## REVISED RESPONSE TO REQUEST FOR ADDITIONAL INFORMATION

### APR1400 Design Certification

Docket No. 52-046

RAI No.: 475-8596  
SRP Section: 10.04.08 – Steam Generator Blowdown System  
Application Section: 10.4.8  
Date of RAI Issue: 05/04/2016

Figure 2.7.1.8-1 Steam Generator Blowdown System

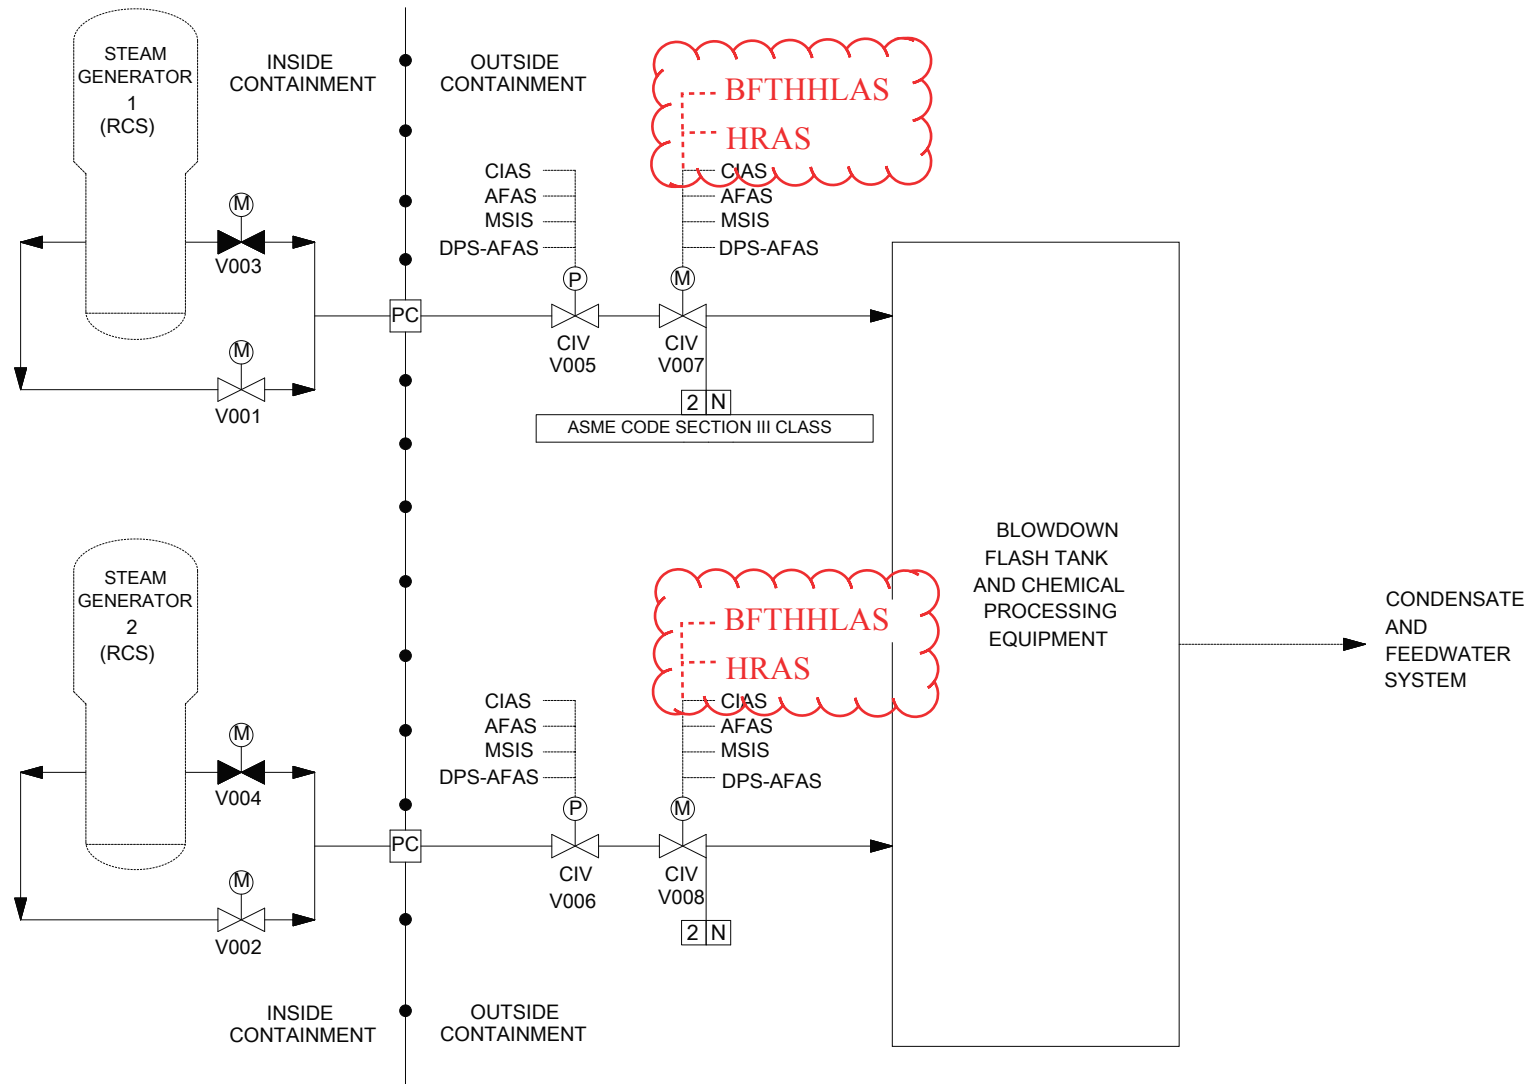
- a. The response proposes listing additional control signals in Tier 1 Table 2.7.1.8-1, but there is no corresponding change proposed for Tier 1 Figure 2.7.1.8-1. Since Figure 2.7.1.8-1 shows the control signals associated with containment isolation valves, provide your plans for revising Figure 2.7.1.8-1 or the basis for not revising it.
- b. The response indicates that Tier 2 Chapter 7 intentionally discusses the instrumentation and controls at a higher level and does not describe individual signals. The staff determined that for consistency and clarity, the signals that activate the containment isolation valves should be identified in Chapter 7, especially in the functional diagrams. Please discuss your plans to add this information to the FSAR.

- a. DCD Tier 1 Figure 2.7.1.8-1 and ACRONYM AND ABBREVIATION LIST will be revised to include the HRAS and the BFTHHLAS signals as indicated in the Attachment. And the signal lines in DCD Tier 2 Figure 10.4.8-1 will be revised to a dashed line as indicated in the Attachment. [In addition, the signal description in DCD Tier 2 Figure 10.4.8-1 will be corrected as indicated in the Attachment.](#)
- b. To activate the containment isolation valves (CIVs), following signals are used:
  1. ESFAS (e.g., SIAS, CSAS, CIAS, MSIS, and AFAS) and DPS (e.g., DPS-AFAS) signals

For example, steam generator blowdown system CIVs 005, 006, 007, and 008 in Figure 2.7.1.8-1 of DCD Tier 1 are actuated by the CIAS, AFAS, MSIS, and DPS-AFAS. However, those CIVs are not related with the SIAS and CSAS.
